Subject: Acton Town Council Comments on the Draft Decision Issued by the Office of Electrical Infrastructure Safety to Approve Southern California Edison Company's 2026-2028 Base Wildfire Mitigation Plan.

Reference: Docket #2026-2028-Base-WMPs.

**COMMENTS SUBMITTED BY THE ACTON TOWN COUNCIL
TO THE CALIFORNIA PUBLIC UTILITIES COMMISSION ON
SCE PSPS POST EVENT REPORTS.**

Figure 6. The Shovel Circuit

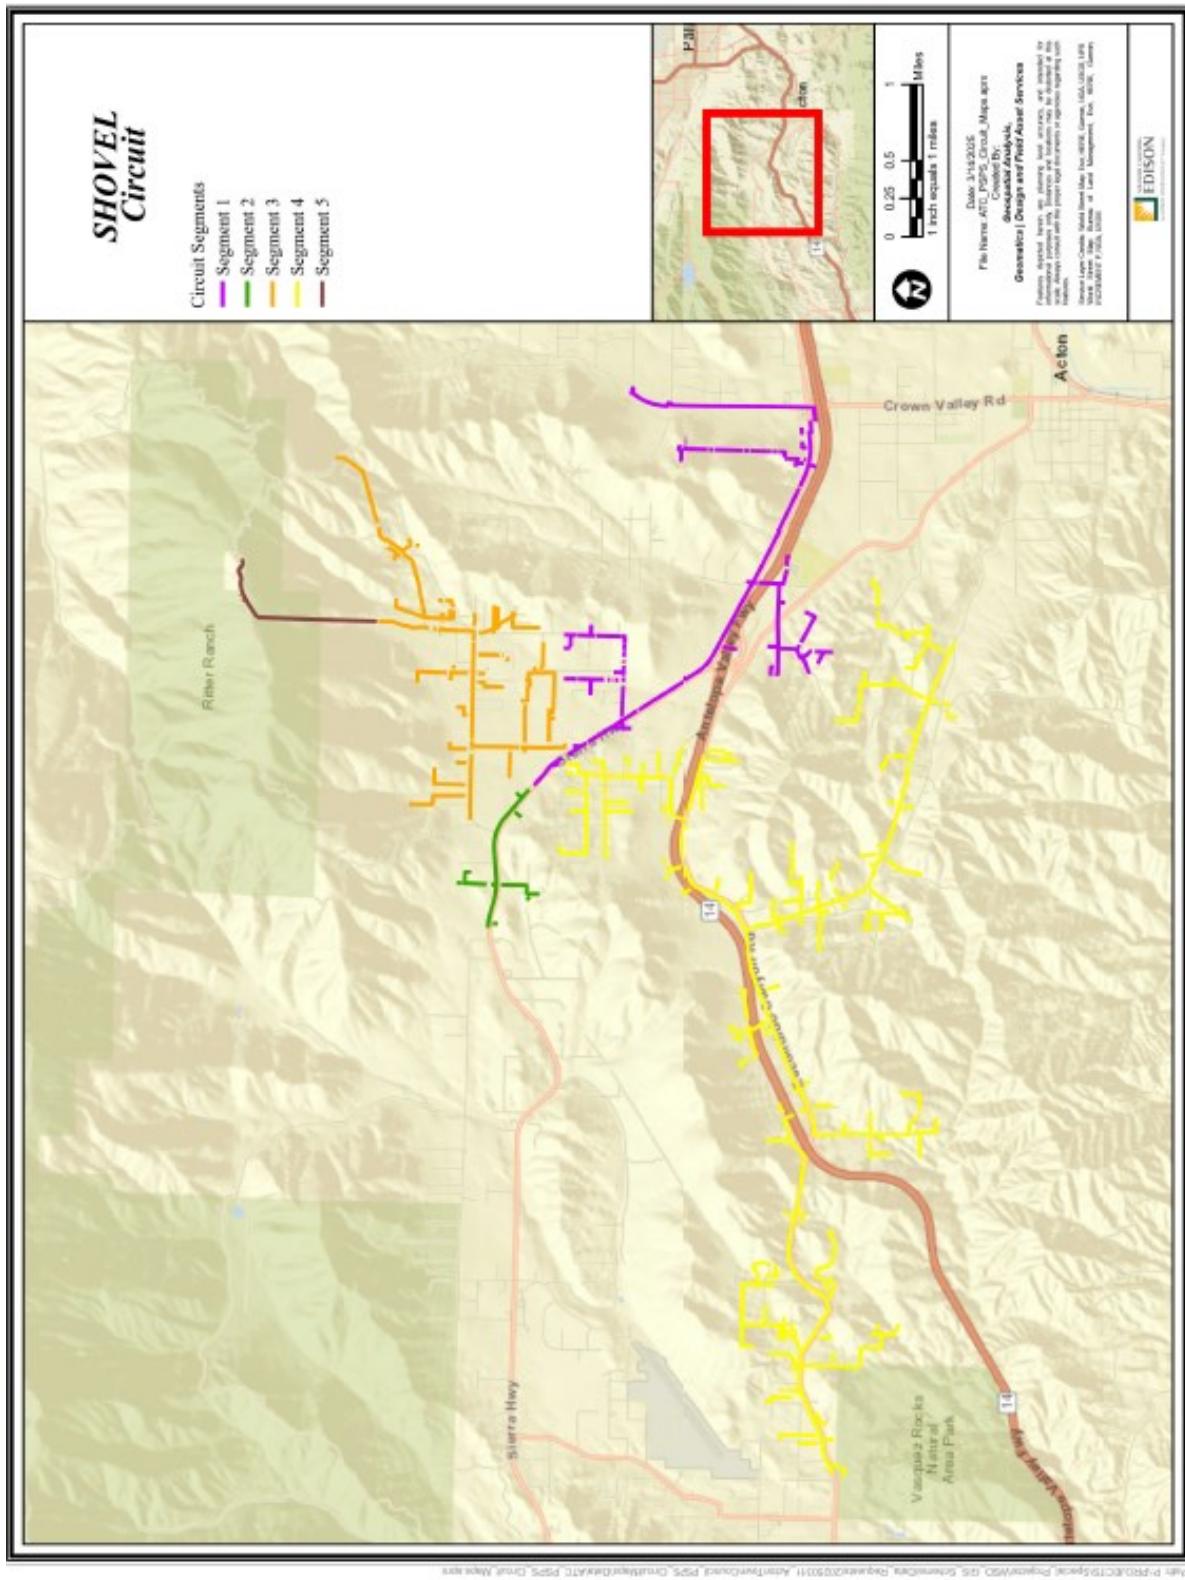
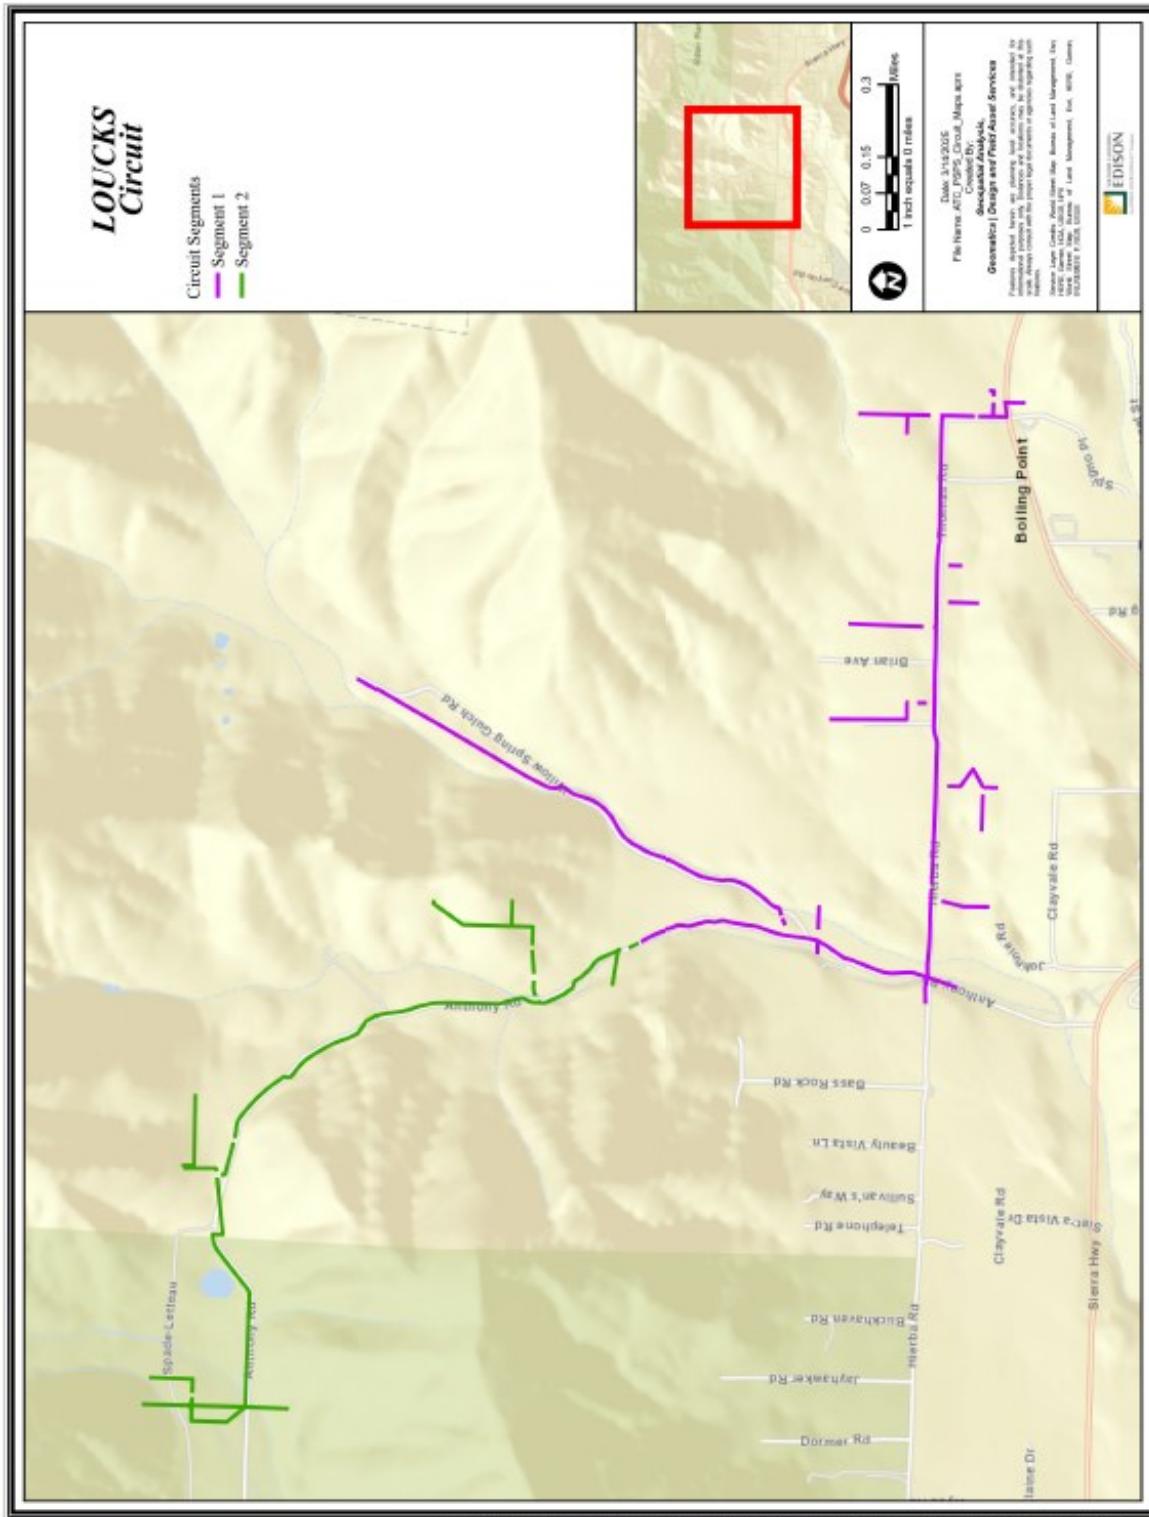
An additional concern relates to SCE’s statements in Footnotes 6, 15, and 22 that SCE uses the term N/A for data pertaining to circuits that are “electrically connected to circuits in scope for potential de-energization.” This vague explanation provides “cover” for SCE’s failure to report data for long lengths of circuits and it also fails to clearly convey the truth; namely, that what SCE calls circuits which are “electrically connected to circuits in scope for potential de-energization” are in fact nothing more than sections of different circuits. For example, what SCE calls the “Loucks Circuit” in Agua Dulce is actually the western end of the Shovel Circuit that is energized in the heart of Acton, so it is not a distinct circuit at all. This fact is revealed in Figures 6 and 7 (which are circuit maps that SCE just provided to the Council): Figure 6 depicts the Shovel Circuit and Figure 7 depicts the “Loucks” circuit. Inspection of these figures reveals that the origin of Segment 1 on the east end of what SCE calls the “Loucks” circuit coincides with the termination of Segment 2 on the west end of the Shovel Circuit; together, they constitute a one very long circuit. In other words, Segments 1 and 2 of “Loucks” are actually extensions of the Shovel circuit; “Loucks” is merely a phantom circuit which should not be misrepresented it as an actual and distinct circuit.

SCE's habit of misrepresenting a single circuit as two distinct circuits makes it impossible for residents who are served by the phantom circuits to understand why their power was shutoff. The phantom "Loucks" circuit again illustrates this point: for years, Agua Dulce residents on the "Loucks" could never understand why their power was constantly being shutoff during SCE PSPS events and SCE's Post Event Reports never shed any light on the matter because they consistently reported "N/A" in place of actual data for the "Loucks" circuit²¹. Additionally, SCE further muddied the waters in the case of the "Loucks" circuit because SCE consistently affiliates the "Loucks" circuit with the Davenport circuit²² (which is energized by the Solemint distribution substation) rather than the Shovel circuit (which is energized by the Acton distribution substation); that is why many residents in Agua Dulce could never understand why the southern portion of the community always had power but the northern portion never had power during PSPS events in which there was no wind in Agua Dulce.

Figure 1. SCE's Sand Canyon Circuit with Annotations Indicating Where Sectionalization Should Have Been Deployed.

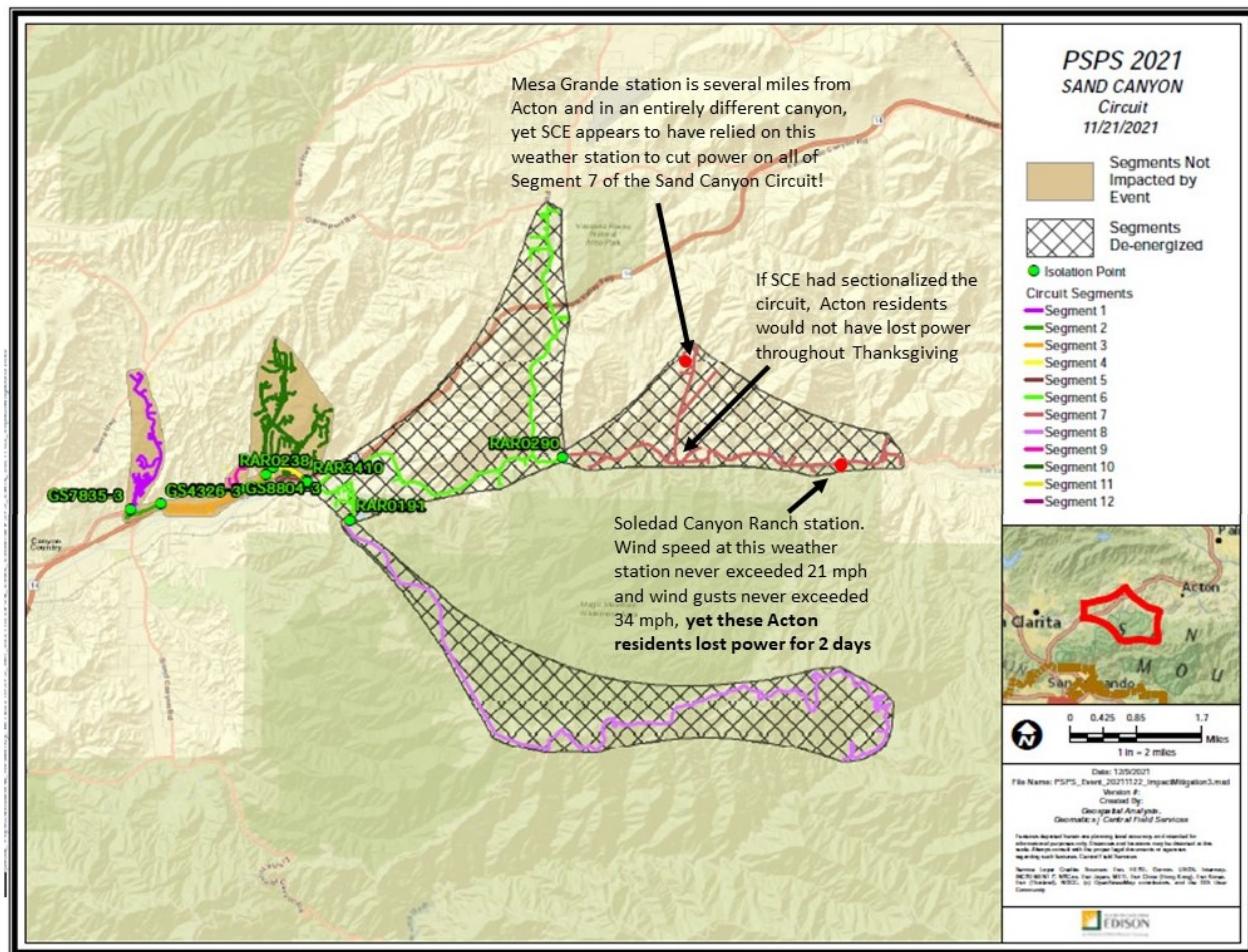
SCE continues to cut power in Acton based on unreasonably low windspeed thresholds; according to the "Event Data Workbook" spreadsheet that SCE submitted with its Post Event Report dated December 10, 2021, SCE denied power to Acton residents over the Thanksgiving holiday based on a sustained windspeed threshold of only 26 mph and a wind gust threshold of only 39 mph. As the ATC has repeatedly pointed out in numerous documents filed with the Commission¹, cutting power to customers at such

low windspeed thresholds violates the reasonableness standard established by Commission Resolution ESRB-8 because such de-energization events are driven by structural deficiencies on SCE's distribution system rather than the presence of "strong

Figure 1. Pick Circuit Map Showing Locations of Weather Stations in the Area.

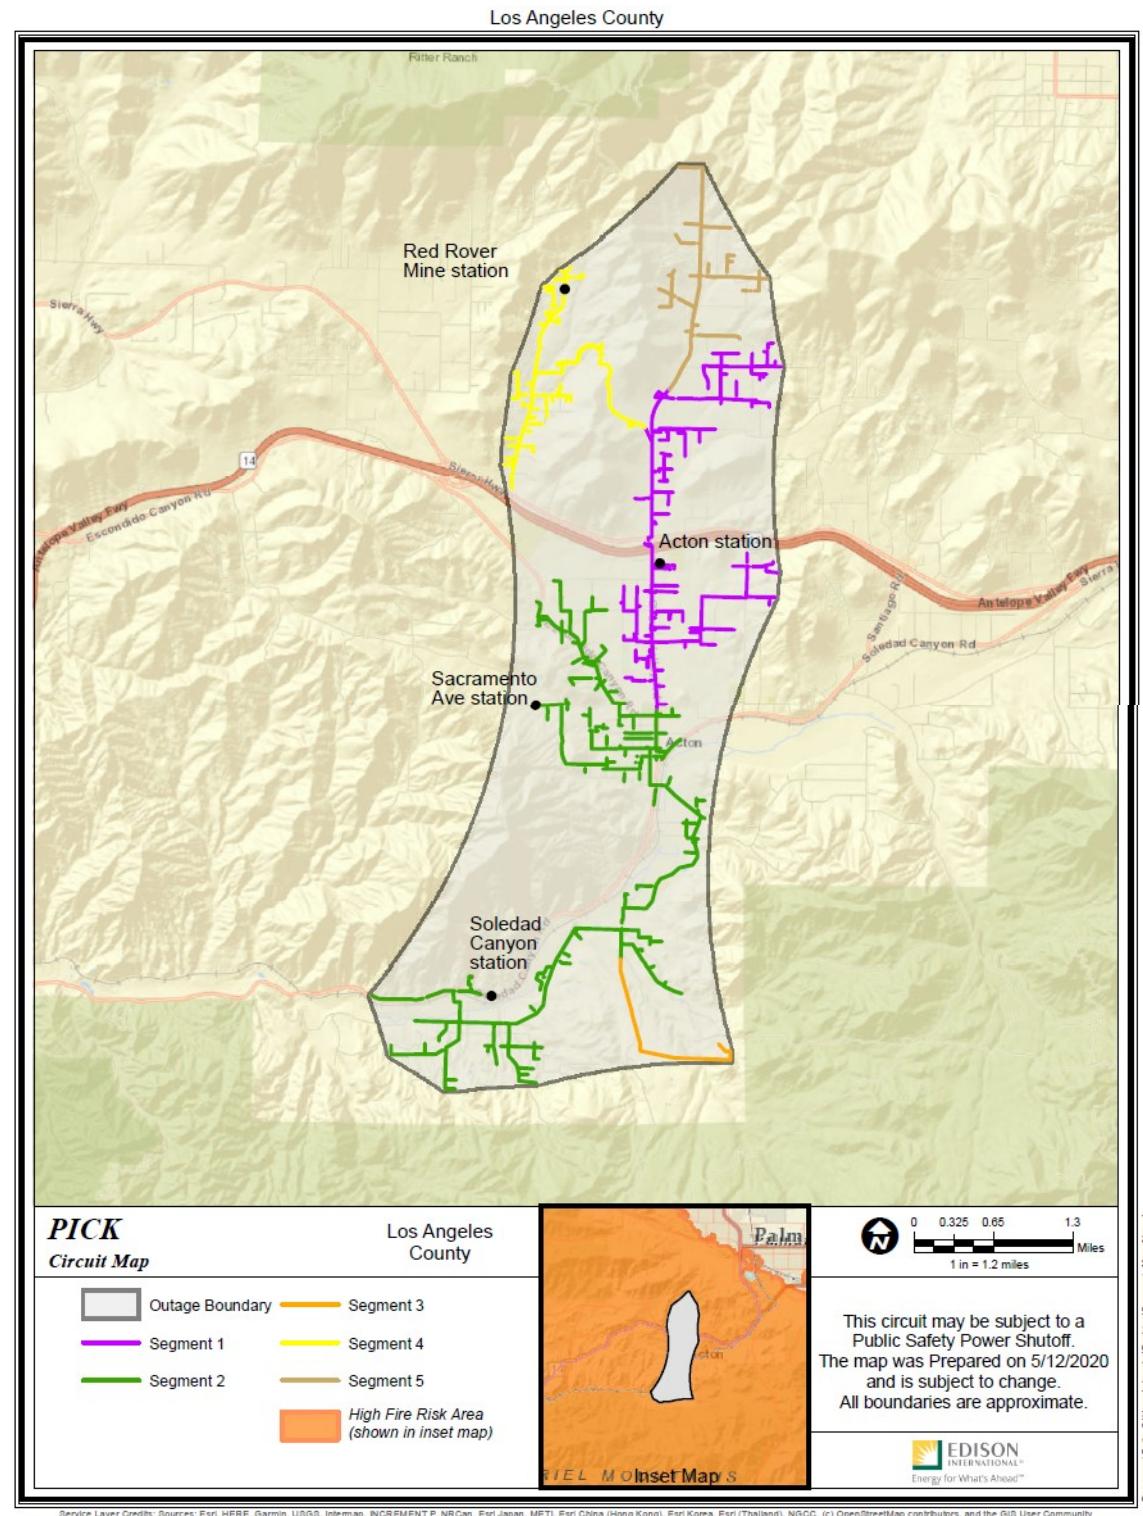
circuit map provided in Figure 1). Because of its remote canyon location, conditions reported by the "Red Rover Mine" weather station are not indicative of conditions on other portions of the Pick circuit. The map provided in Figure 1 also shows that Segment 4 of the "Pick Circuit" can be isolated and de-energized without affecting other portions of the "Pick" circuit if local conditions reported by the Red Rover Mine weather station warrant. Accordingly, SCE should not have de-energized Segment 5 of the "Pick" circuit on December 3 based on wind speed measurements at the Red Rover Mine station; instead, SCE should have employed sectionalization and de-energized just "Pick" Segment 4 and allowed Segment 5 to remain energized. Furthermore, and as shown by the December 3 windspeed data provided in Attachment C that was collected from the "Acton" weather station (which is also shown in Figure 1) windspeeds did not exceed 21.4 mph (sustained) or 37.3 mph (gusts), so de-energizing other "Pick" segments was not warranted. Taken together, these facts reveal that SCE did not reasonably rely on sectionalization of the "Pick" circuit as required by ESRB-8 to reduce PSPS impacts on December 3, 2020.
